# **HEDCO BUILDING ROOFING AND SEISMIC IMPROVEMENTS**

## **UNIVERSITY OF UTAH**

**Project Number: 03088750**

**Project # 03088750**  
**Addendum Number 1**  
**April 21, 2004**

C1A  
S104

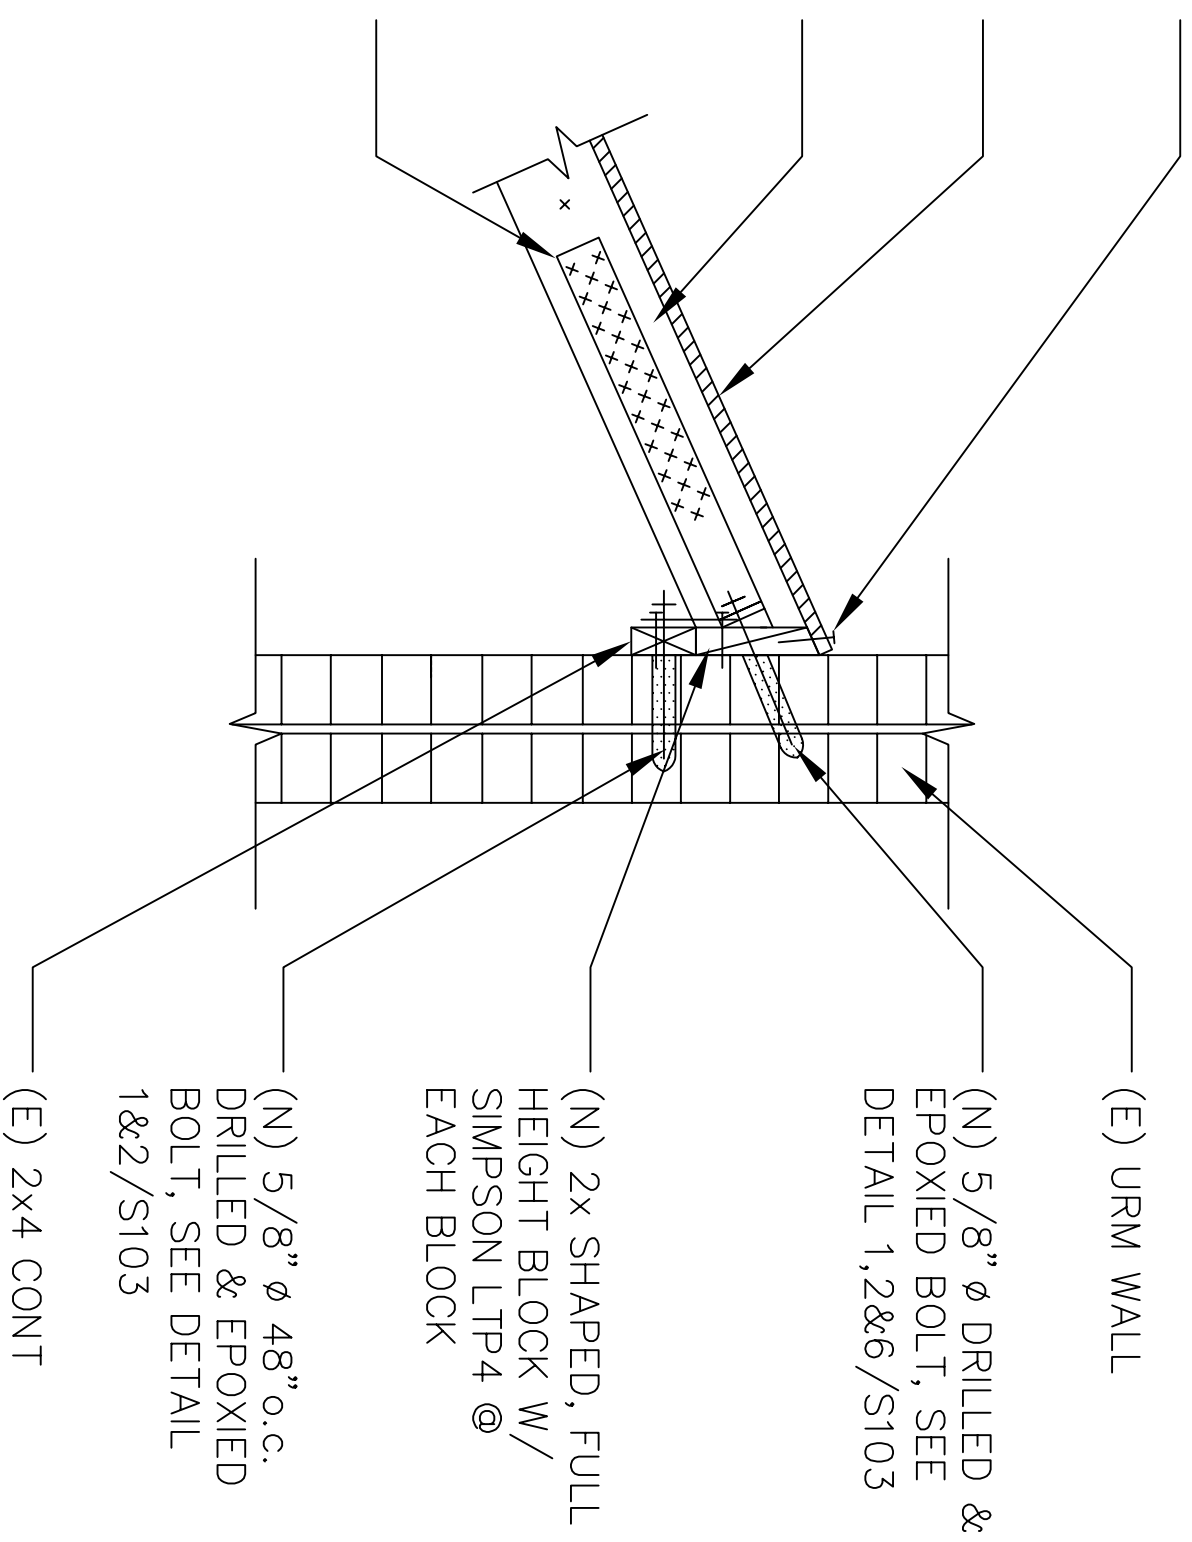
- 6- The west, multistory building classroom roof has two additional details that have been added in addition to detail C1/S104, which has been modified and is attached. These two details are C1A/S104 & C1B/S104 and are attached. Detail C1A/S104 is the attachment of the parapet and detail C1B/S104 is the attachment back to the sloped roof. Details C1A/S104 & C1B/S104 are to be called out everywhere detail C1/S104 is called out.

(N) REQ'D BOUNDARY  
STAPLING, SEE PLAN  
& SCHEDULE

(N) SHEATHING, SEE  
PLAN & SCHEDULE

(N) 2x6 ROOF KICKER  
W/ SISTERED (N) 2x6  
GLUED & NAILED W/  
10d COMMON @ 4" o.c.  
(BUTT TIGHT TO (E)  
2x10)

(N) SIMPSON LTT19 @  
48" o.c. WITH BEVELED  
WASHERS
